ADDENDUM No. 1
BID DOCUMENTS FOR
MANCHESTER • BOSTON REGIONAL AIRPORT
PARKING GARAGE: LEVEL-4 FLOOR & LEVEL-3 CEILING
SEALANTS, WATERPROOFING, & MISCELLANEOUS REPAIRS PROJECT
MHT / City Bid # FY22-805-50

May 2, 2022

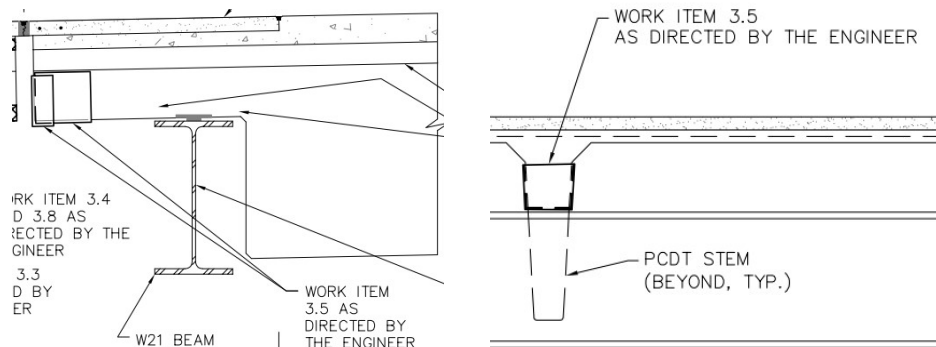
Q2. “Please confirm for 5.3 – Floor Slab Joint Repair – Remove and Replace failed T/T Flange Joint Sealants – No water testing (exploratory or verification) is needed? ”

a. Refer to Specification Section 02000 Work Item Scopes, Subsection 5.3, Item 1 and Item 10:

1. Initial pressure washing and exploratory water testing: (NOT REQUIRED)

10. Verification water testing (NOT REQUIRED)

As shown on the Plans and as specifically pointed out at the pre-Bid Meeting / Site Walk, the T/T Flange Joint Sealants on this floor have previously been repaired and covered with Item 2.7J (one-foot-wide nylon reinforced Traffic Topping) therefore the joints are covered and there are no exposed joints to pressure wash and water test.
